MINUTES OF THE ARCHITECTURAL REVIEW BOARD

January 21, 2021

617 Crown Cove

Variance

**BASEMENT_PLAN**
1/8" = 1'-0"

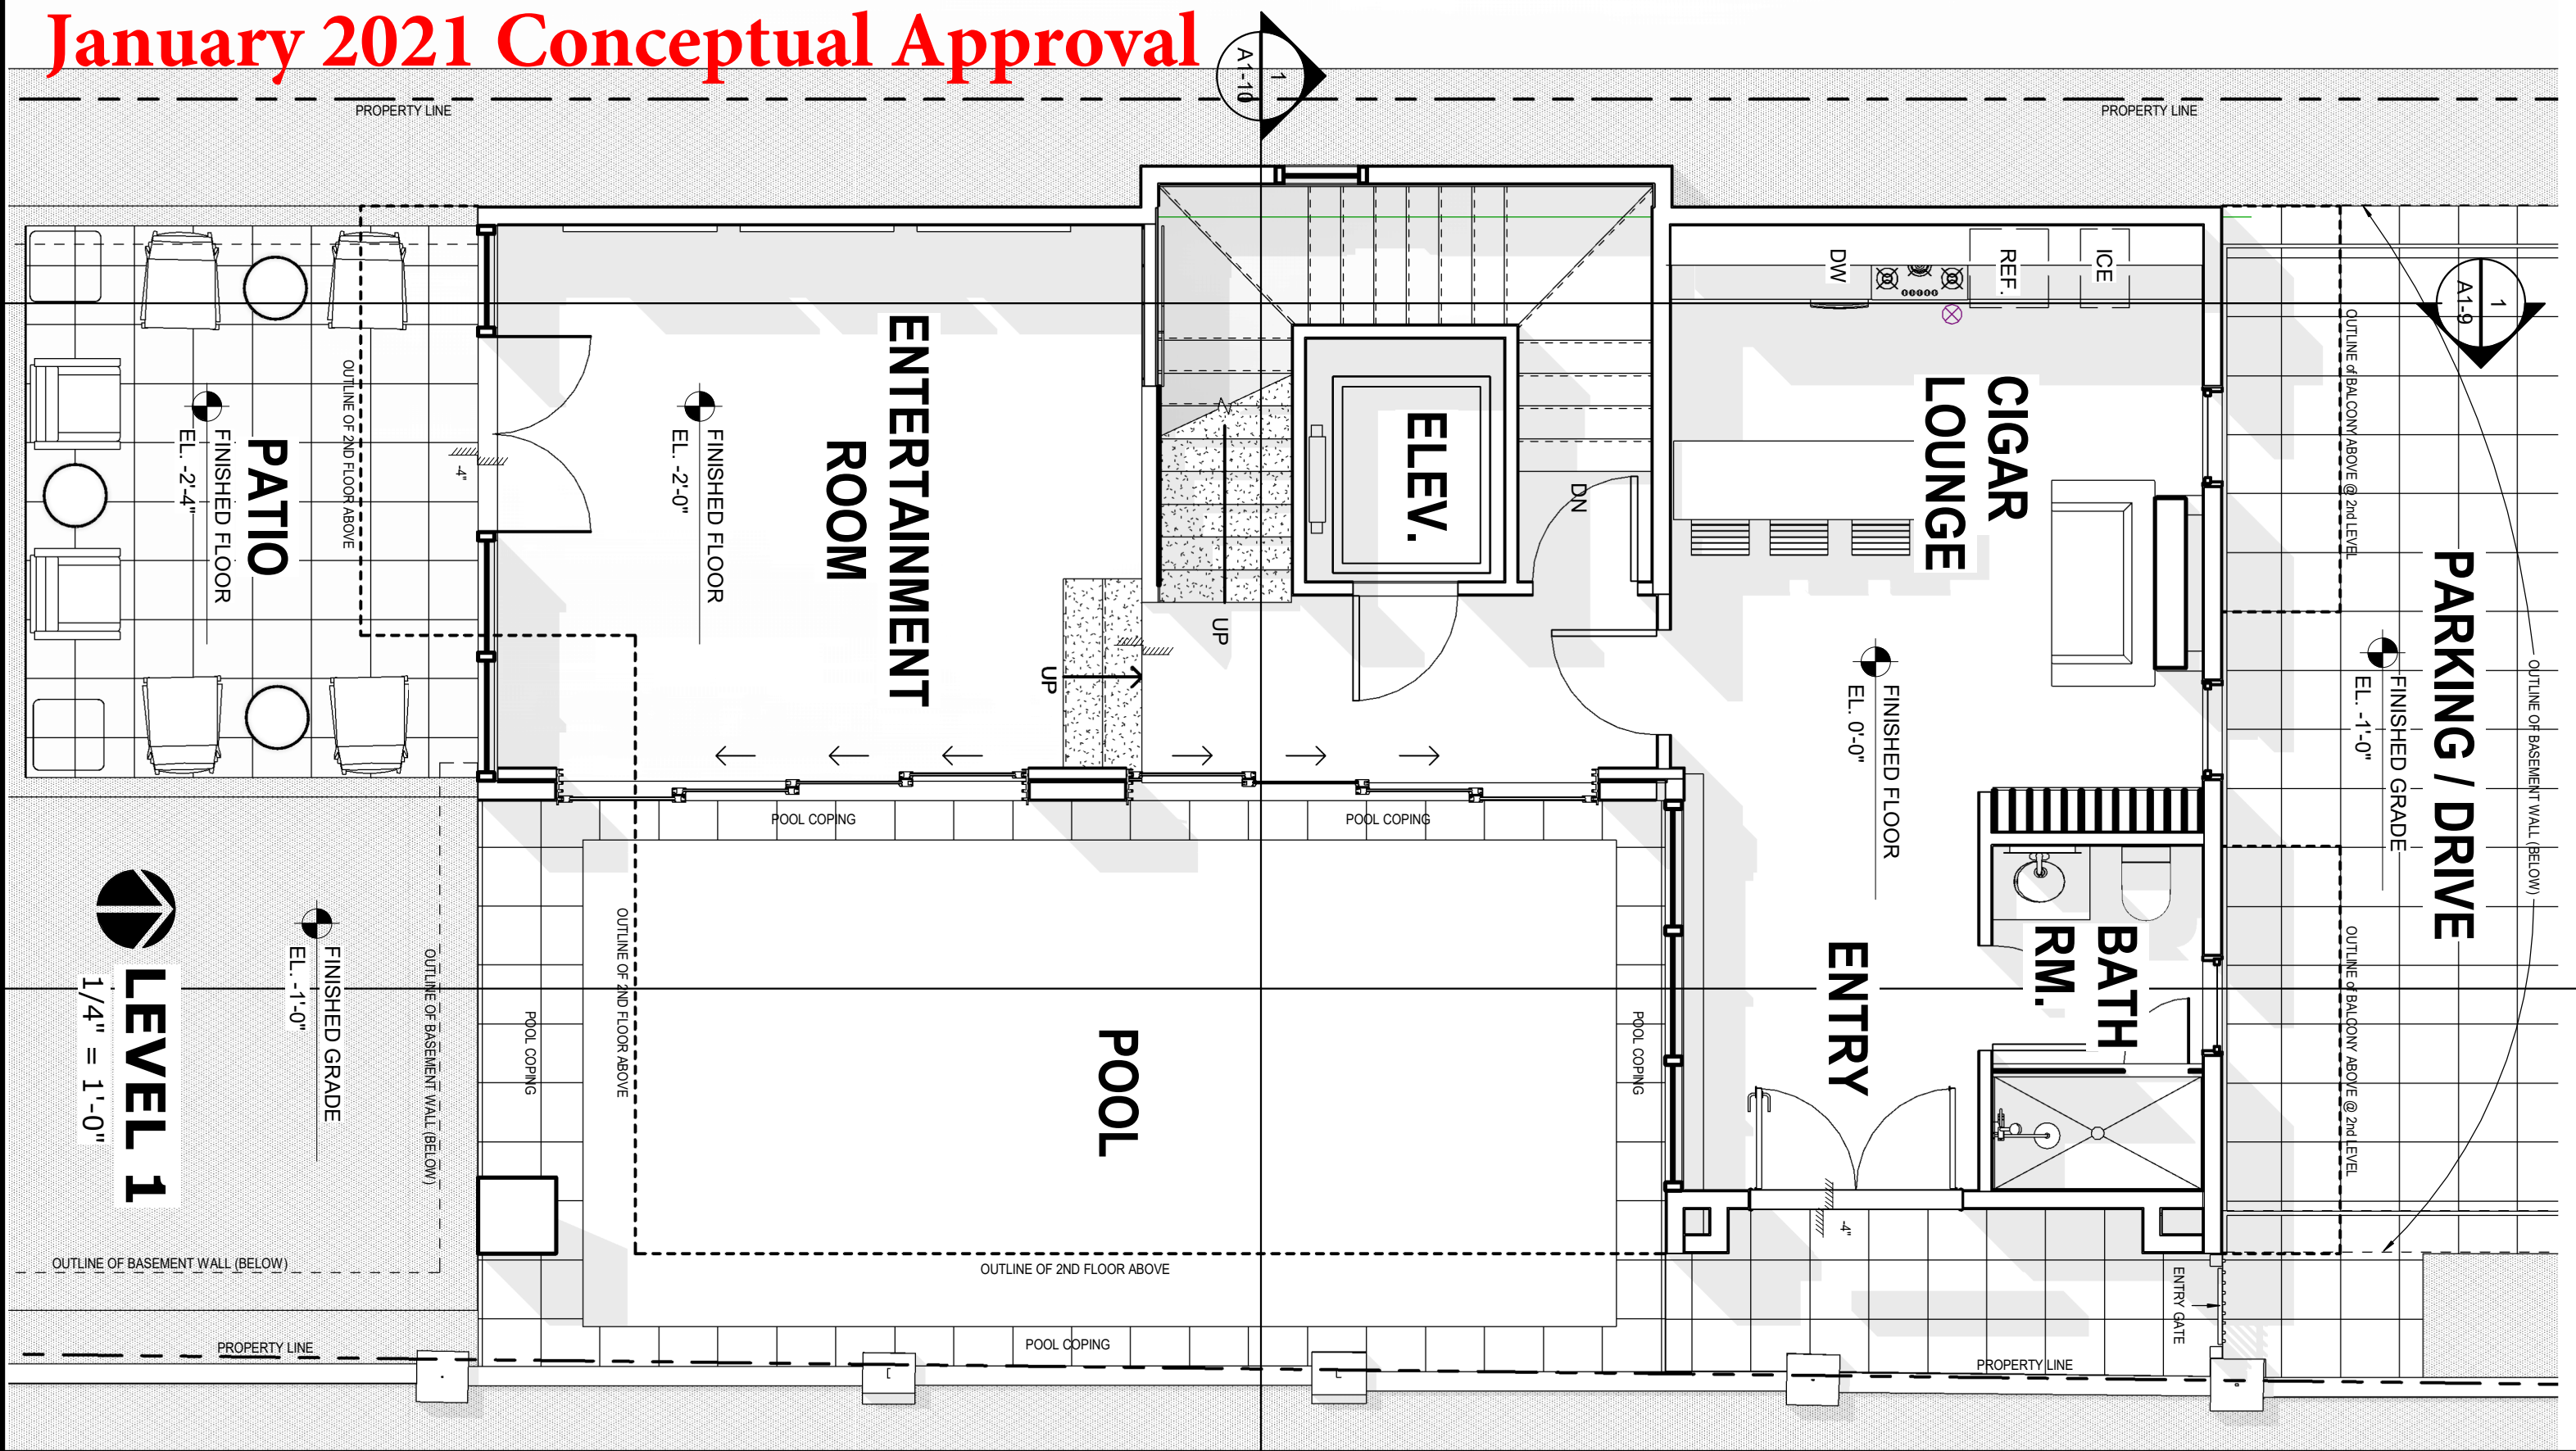
Board Member Ramos addressed the basement plan and a reduction on the east side. Staff explained the way the Code classified yards was unobstructed space from the ground up, and the subsurface basement area was not included as part of the measurement. (Board Member Mead left the meeting at this time and Board Member Fogarty assume the Vice Chair function.) Staff furnished letters of support from the Crown Cove HOA for the project. Staff also offered this SSD was meant to be flexible in its design.
